Application No. 10/582,809
Paper Dated: December 4, 2008
In Reply to USPTO Correspondence of August 5, 2008
Attorney Docket No. 0388-061722

AMENDMENTS TO THE DRAWINGS

REMARKS

Fig. 1

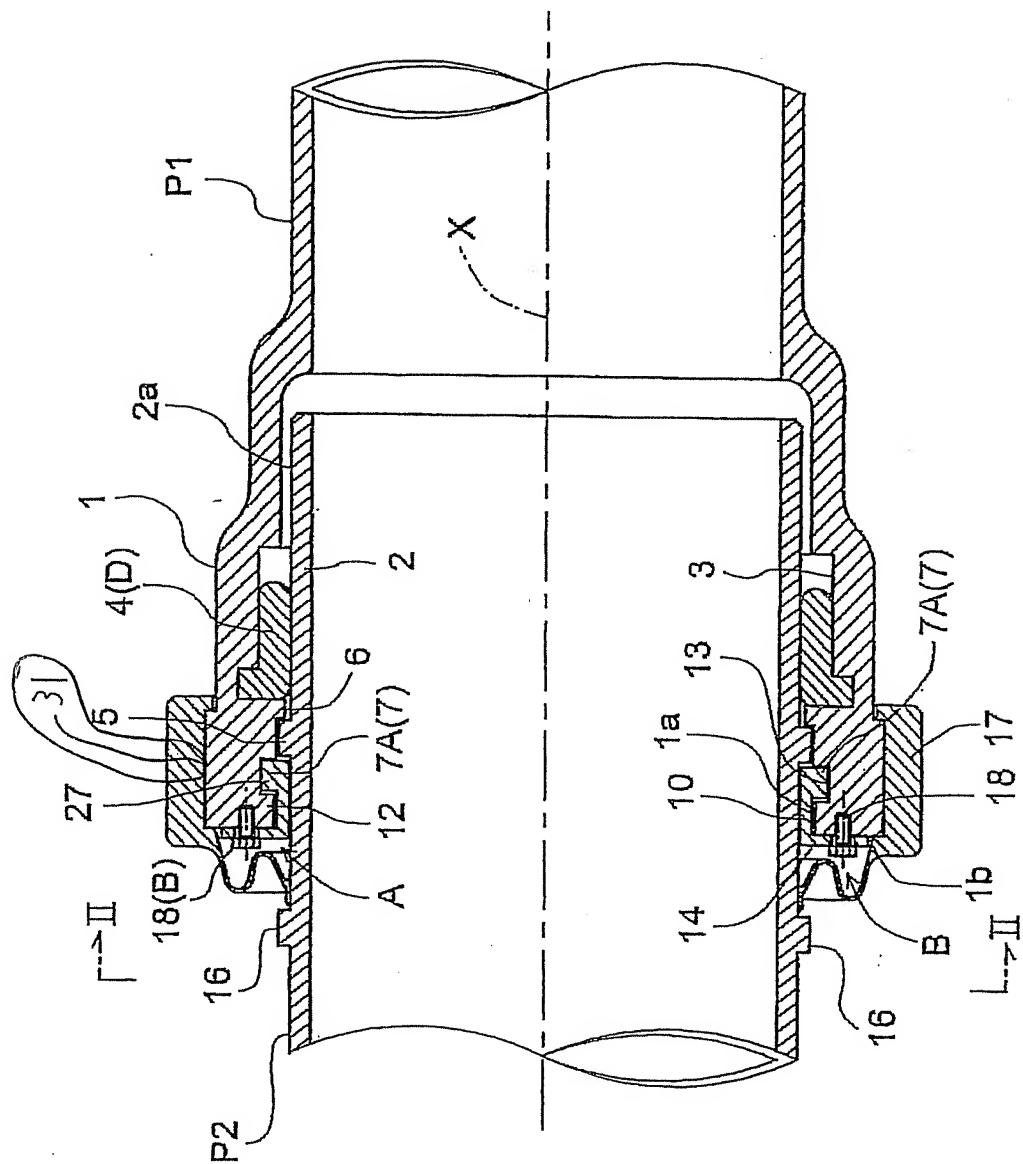
The drawings stand objected to for minor informalities. Specifically, the Examiner has objected to the drawings for failing to comply with 37 C.F.R. §1.84(p)(4) because reference character "27" has been used to designate both the flange-shaped attaching portion in Figs. 1, 15 and 22 and the engaging pieces in Figs. 16 and 17, and reference character "15" has been used to designate both the control pinching portion in Figs. 2-5, 13 and 17 and the control knobs in Figs. 18 and 19. The Examiner has also objected to Fig. 25 for lacking a legend such as --Prior Art-- because only that which is old is illustrated. Finally, the Examiner has objected to Fig. 1 because the line for reference character "27" appears to be pointing to the wrong area.

The Applicants believe that replacement Figs. 1, 15, 22 and 25, along with the above amendments to the specification, overcome the Examiner's objections. Amendments to Figs. 1, 15, 22 and 25 are indicated in the attached annotated copies of Figs. 1, 15, 22 and 25. Reconsideration and withdrawal of these objections is respectfully requested.
